PIK/L3690-1/cam

22 August 2025

**RE: s67 RESPONSE LETTER NO. 1 FOR DRURY QUARRY, SUTTON BLOCK  
BUN60449474-FTAA-2503-1037**

This letter provides a peer review of the groundwater s67 responses using the same query numbering adopted by PDP (2025b).

Figure 15 (PDP)  
Inferred Drawdown Zone in Greywacke for Dewatering at RL-5m

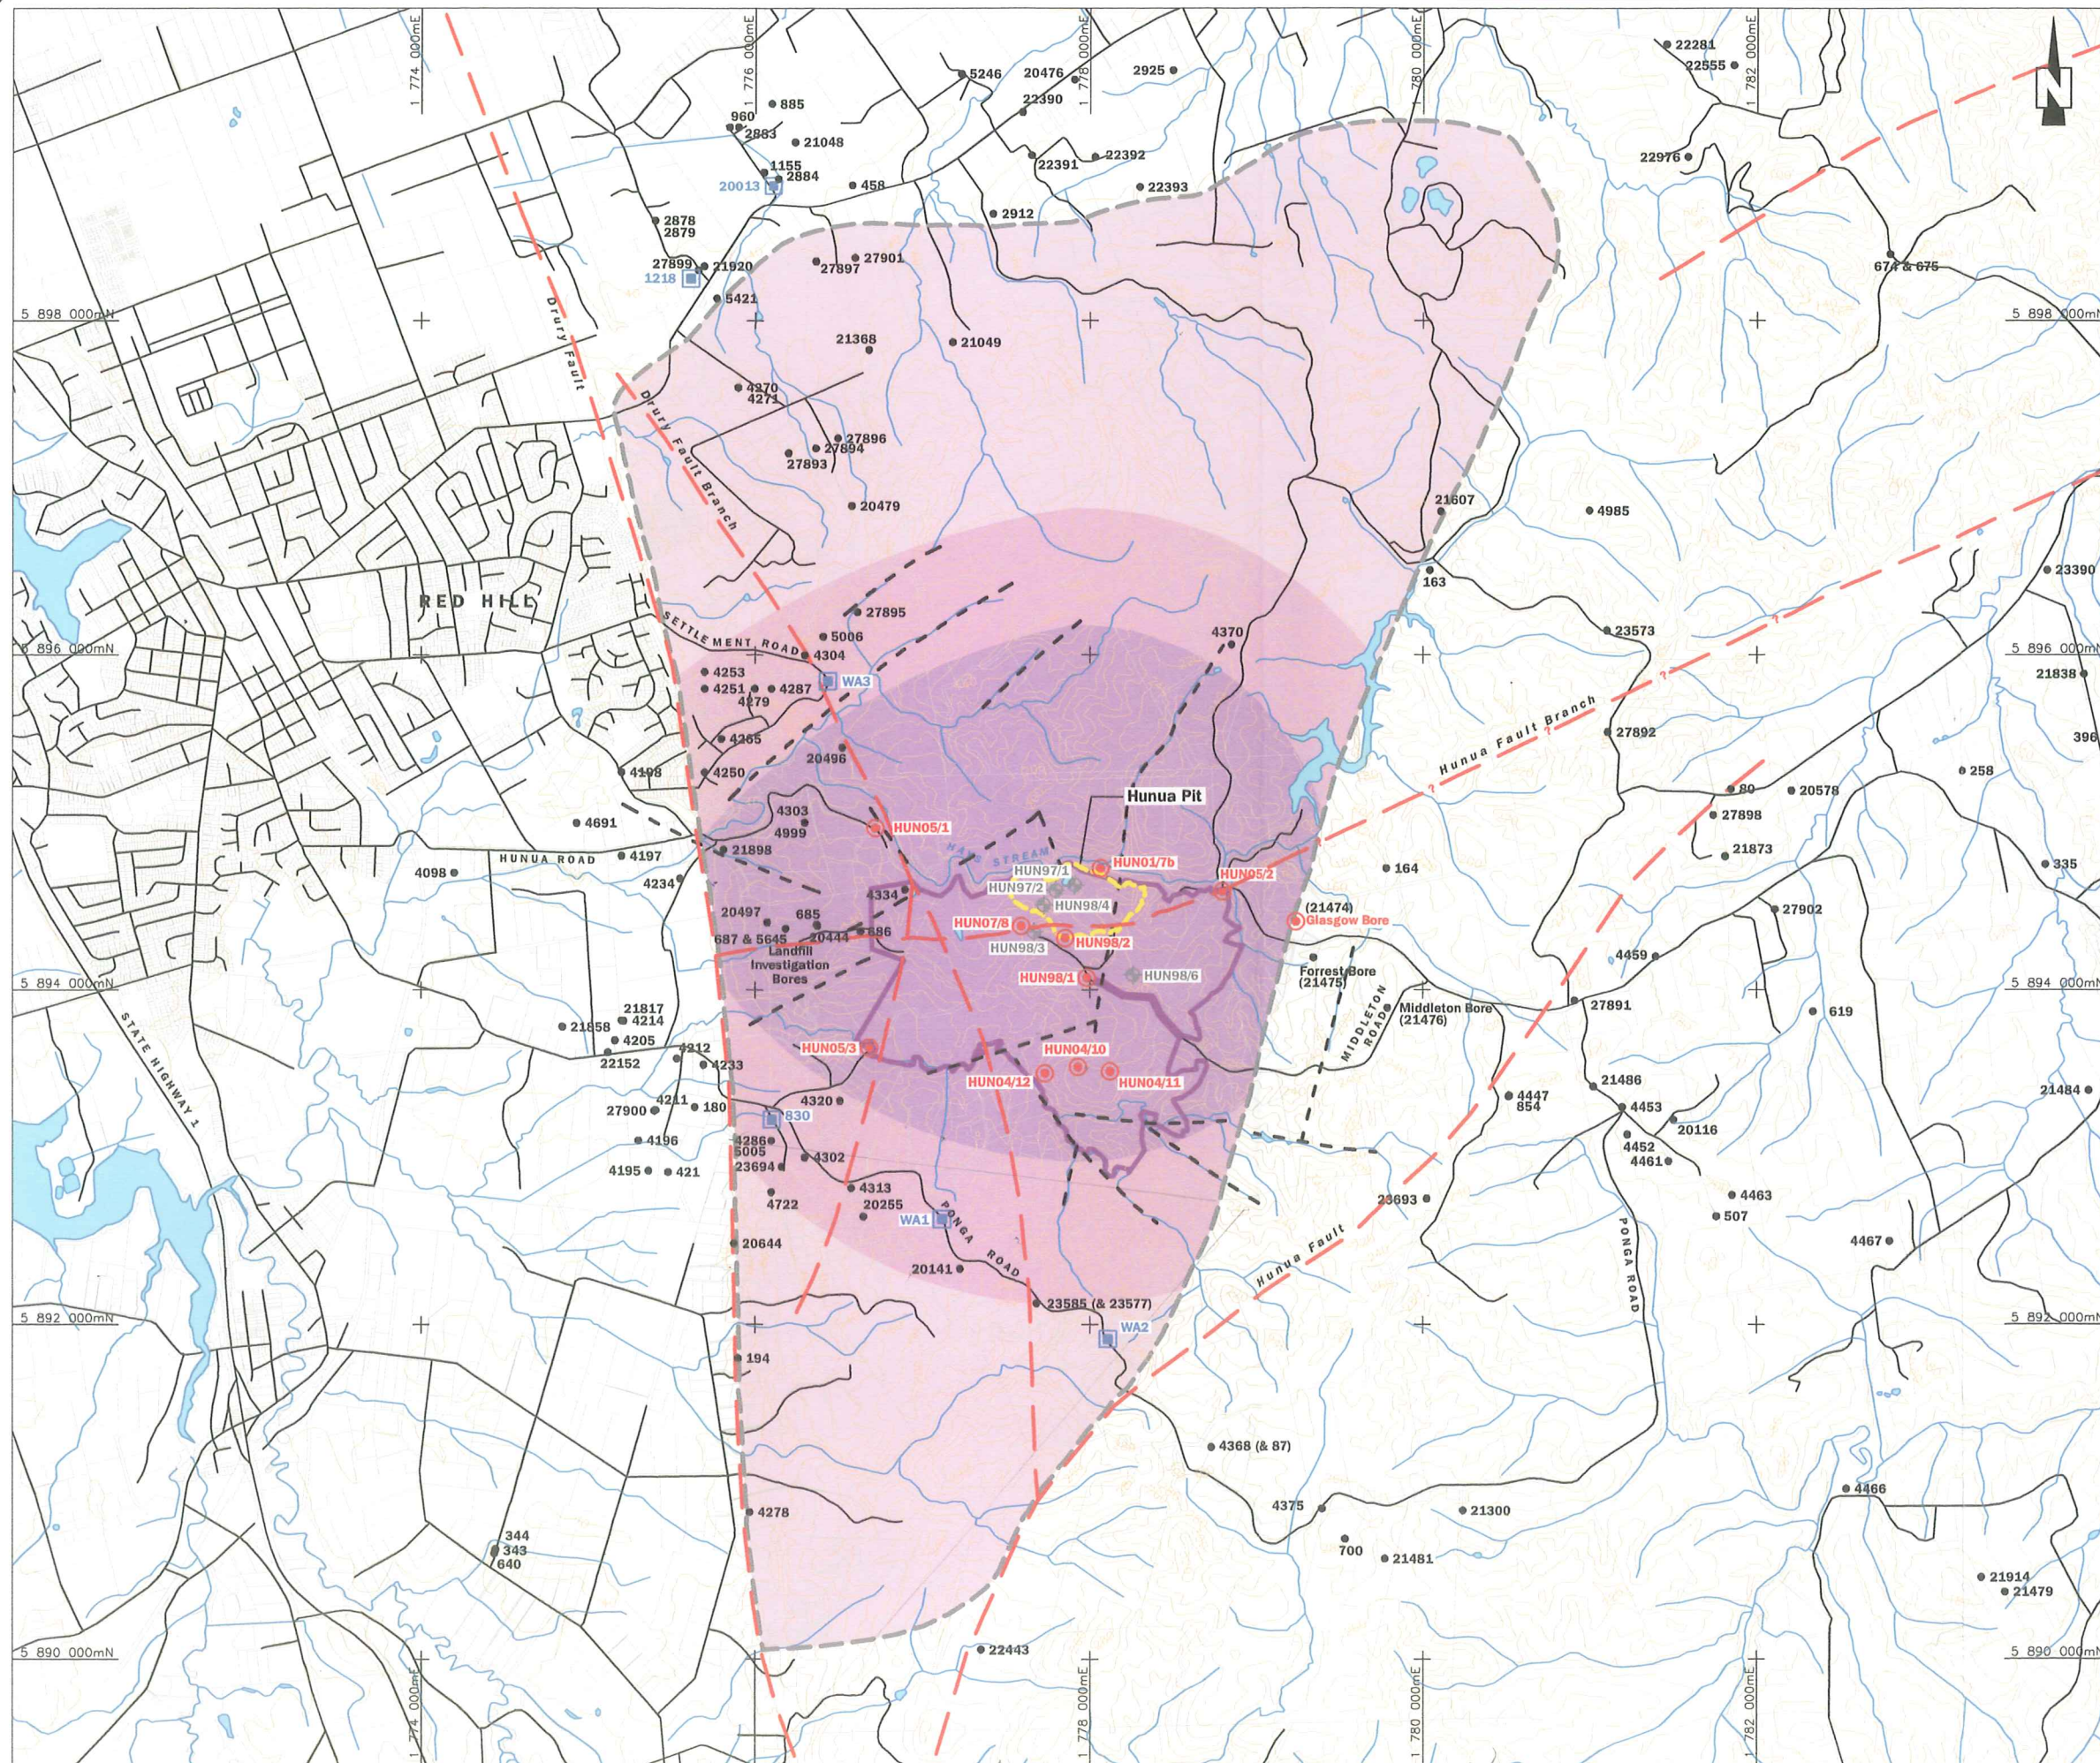
Attached in Appendix A are the predicted inferred drawdown zones for the Hunua Pit Quarry with dewatering to RL-5m from PDP (2011). A similar drawdown plot is required for the Sutton Block application.

PDP (2025b) considers that cumulative effects from the consent Drury and Hunua quarries can be ignored due to the deep RL-60m dewatering levels associated with the proposed Sutton quarry. This position is accepted for the Drury Quarry but not for the Hunua Quarry which has a dewatering level at RL-5m, and is located 3.5km to the north of the site.

The PDP (2011), Figure 15 (Appendix A), shows the Hunua Pit Quarry zone of dewatering extending beyond the northern edge to outside of the 7.5km Sutton Block zone of dewatering influence. Therefore, cumulative drawdown effects from the Hunua Quarry need to be considered for the Sutton Block application.

*Proposed monitoring of shallow and deep groundwater levels to the east of the Sutton Block expansion within the predicted 7.5km zone of dewatering influence. Listing of groundwater monitoring bores in draft consent conditions.*
